**PRE DEVELOPMENT APPLICATION ASSEST PROTECTION
ZONE/LANDSCAPING REPORT**

Reference No: Compliance DBKL2024-278

Site Address: 113 Orchard Street, Warriewood, NSW

Project: Infill Development – Construction of a new Dwelling

Figure 1. Detail of tree removal

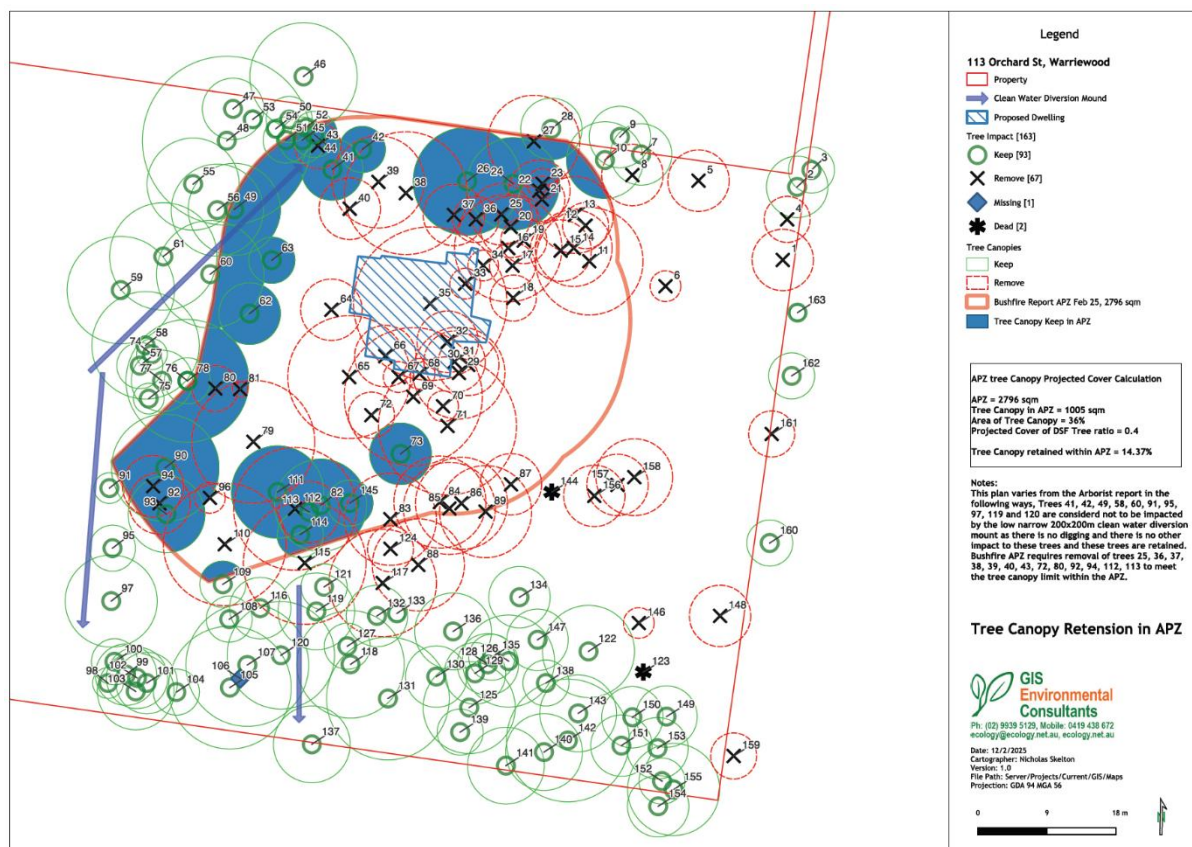
Notes as per Arborist and Ecological Services Recommendations: In my opinion these provisions are being followed as per the requirements of Appendix 4 of Planning for Bush Fire Protection 2019. The crown coverage estimated in the APZ is at 14.37%. This meets the IPA requirement of the PBP 2019 which says 'should be 15%' crown coverage. The arborist and ecologist have provided tree removal and Vegetation Management Plans (in perpetuity) to support the PBP 2019. These aforementioned documents embrace the requirements of the PBP 2019 with environmental and ecological planning, sustainability and sensibility that will nurture the requirements of the consent authority, NSW RFS, and planners with the client's needs, protection and survivability in the event of an extreme bushfire event.
